APPLICATION FOR PERMISSION
UNDER SECTION 16 OF
THE TOWN PLANNING ORDINANCE
(CAP.131)

For Official Use Only 請勿填寫此欄	Application No. 申請編號	A/ML-MP/305
	Date Received 收到日期	26 APR 2021

(b) Intended use/development 有意進行的用途/發展	Utility Installation for Private Project (underground stormwater drainage pipe)

Comments on the planning application for the proposed Utility Installation for Private Project (Underground Stormwater Drainage Pipe) and associated Filling and Excavation of Land at Tam Kon Chau Road, Mai Po (A/YL-MP/305)

Figure 1. Noise mitigation at PSFSC proposed in the EEA and used for simulation of noise contours under the mitigated scenario (extracted from Figure A3-3 of the PSFSC EEA).

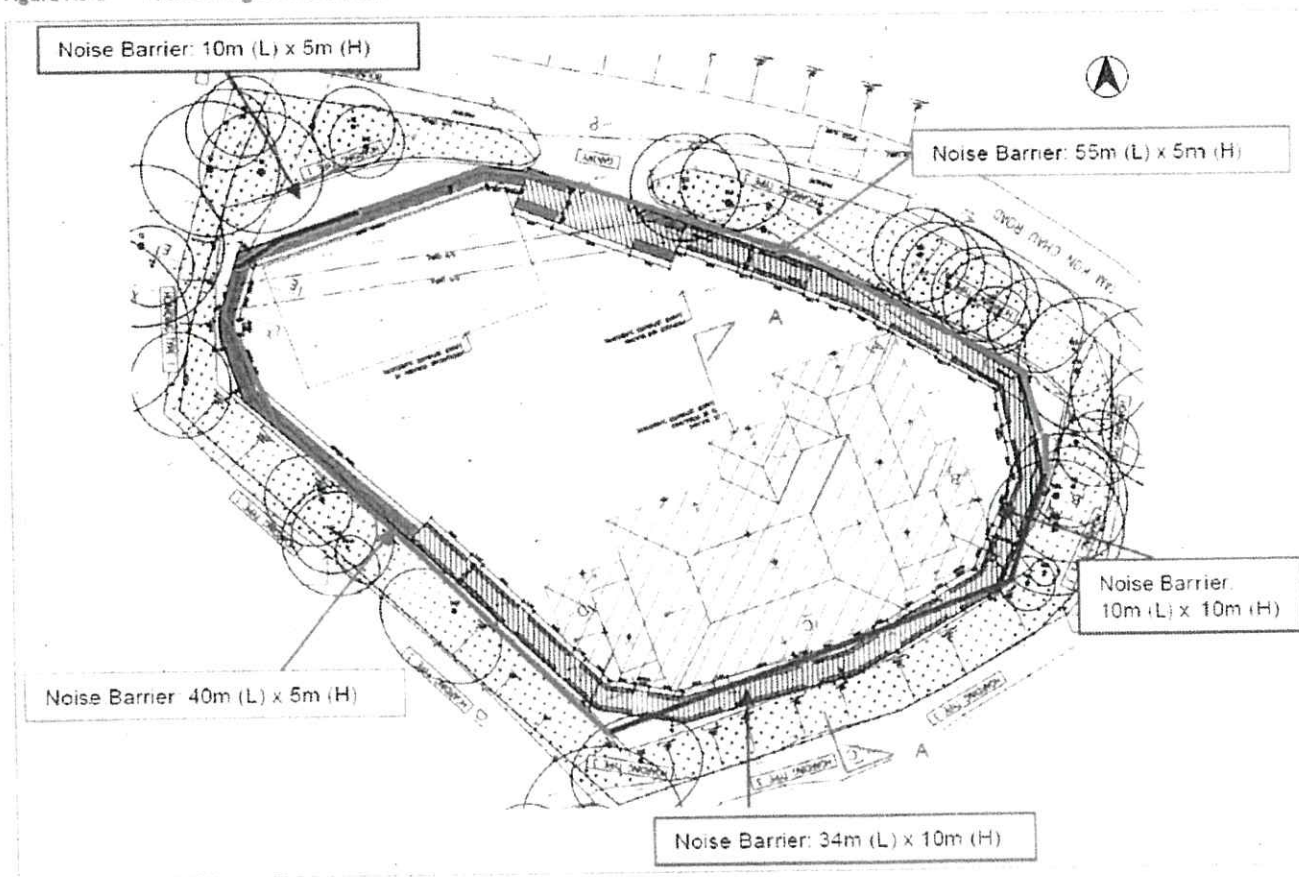
3.1. A.6.53 of PSFSC EEA stated that *"there is no line of sight from the PSFSC (due to screening by tress and, to a lesser extent, by buildings), so the only potential disturbance impact would be that of noise"*. The current background noise level at PSFSC is 54dB (Table A3-3 of the PSFSC EEA). Comparing Figures A3-1, A3-2 and A3-4 of PSFSC EEA, noise levels at the residential areas were significantly reduced with the use of 5m and 10m noise barriers under the mitigated scenario (Figure 1). **However, there seems to be little noise reduction in the fishponds, wetlands and Gei Wais. The mitigated noise level is still predicted to range from 66dB to 86dB, just like the noise contours in the unmitigated scenario (Figure 2).**
